CERTIFICATE OF APPROPRIATENESS APPLICATION FORM

Address 3324 Morrison

PROPERTY ADDRESS: 3324 Morrison - Revision

Proposed is a revision to the COA issued for 3324 Morrison. The skirt around the house, both existing and addition will be brick piers with wood slats in between. The garage will have a half bathroom added to it. See attached drawings for details.

PROPOSED ELEVATIONS

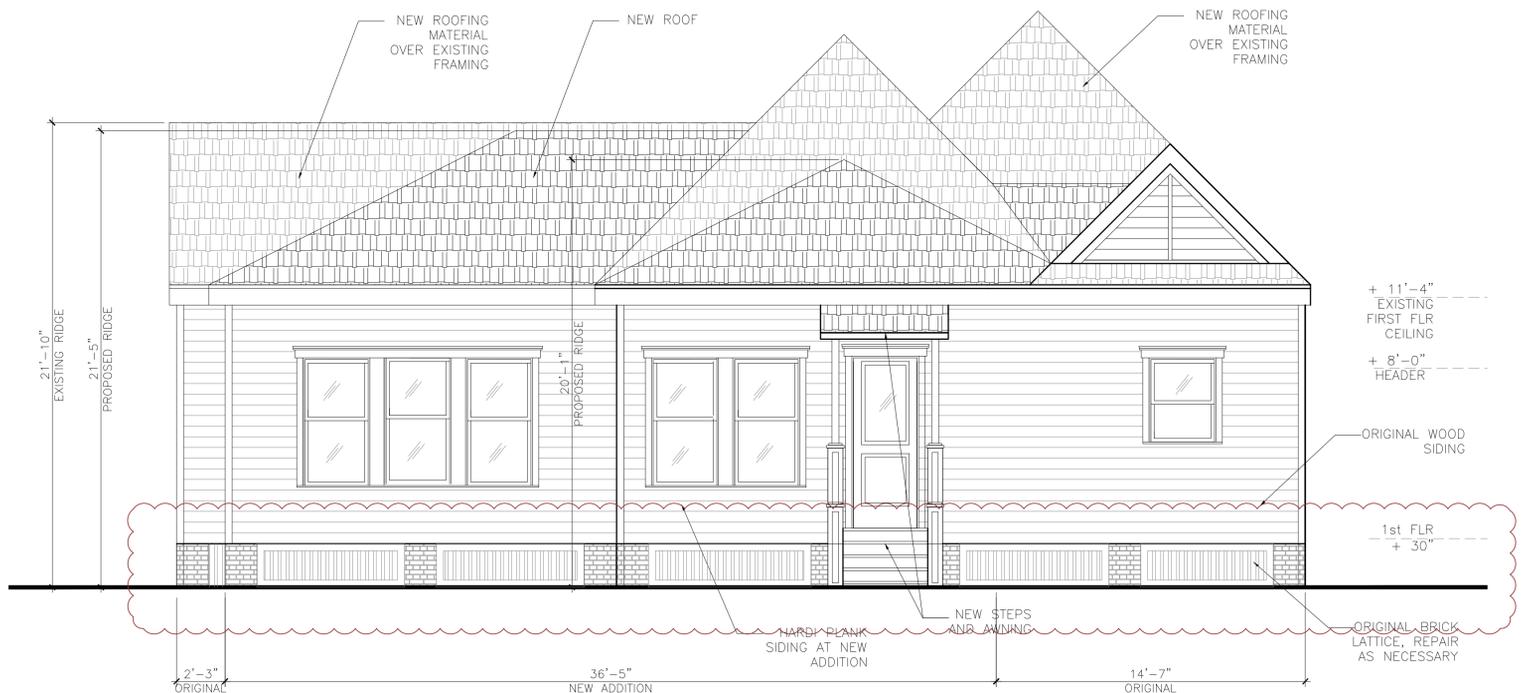
Existing Brick Skirt

Proposed Brick Piers with Wood Slats
